**UPPER UWCHLAN TOWNSHIP
PLANNING COMMISSION**

AGENDA

May 10, 2018

Detail of Eagleview Lot 1B - Maintenance Area Preliminary Land Development

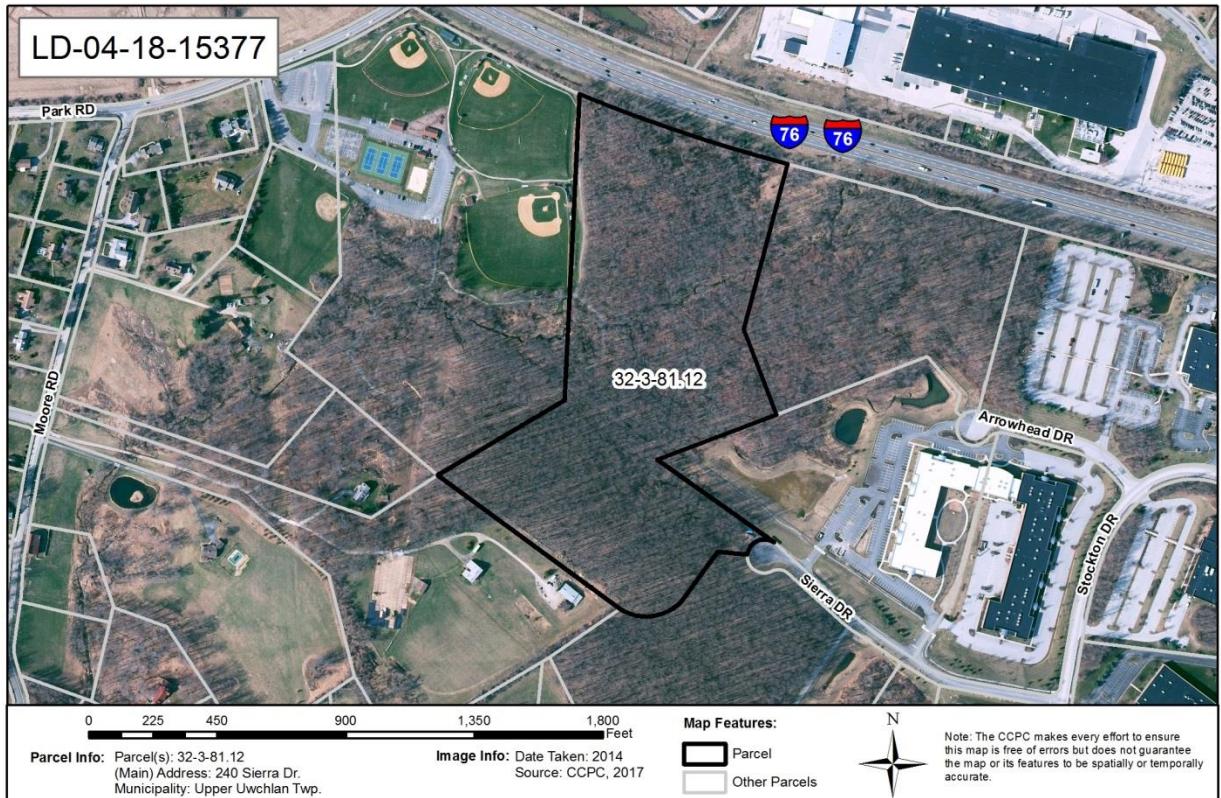
RECOMMENDATION: The County Planning Commission recommends that the issues raised in this letter should be addressed and all Township issues should be resolved before action is taken on this land development plan.
